Product Change Notification: PCN-21-122303

PCN Date: 02-DEC-21

General Product Description:

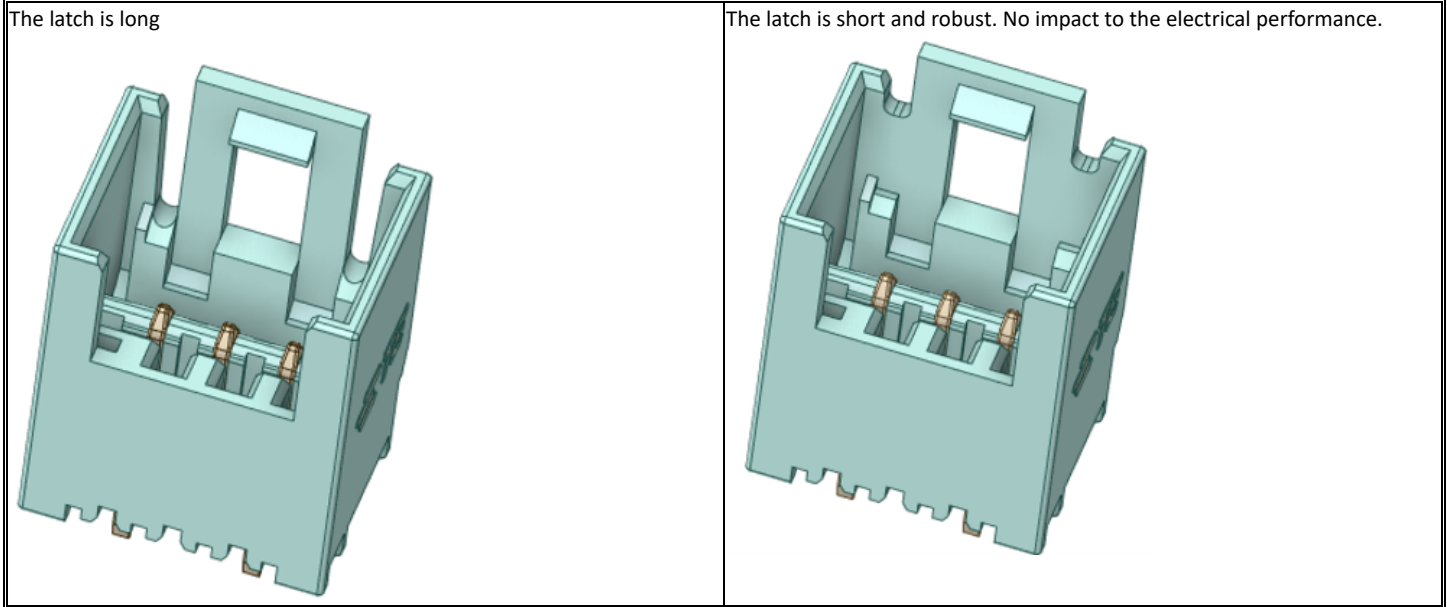
Please be aware of an upcoming feature change to the listed part numbers. 3-2232960-4 3-2232960-3 2-2232960-3 2-2232962-3 1-2232960-4 2364721-3 2-2232960-4 1-2232960-3 5-2232960-3 8-2232960-3 4-2232960-4 6-2232960-3 1-2232962-3 4-2232960-3 Before: Latch length is long. After: Latch length is short. Reference performance test data: Reduce the length of the latch to make it more robust, no impact to the electrical performance.
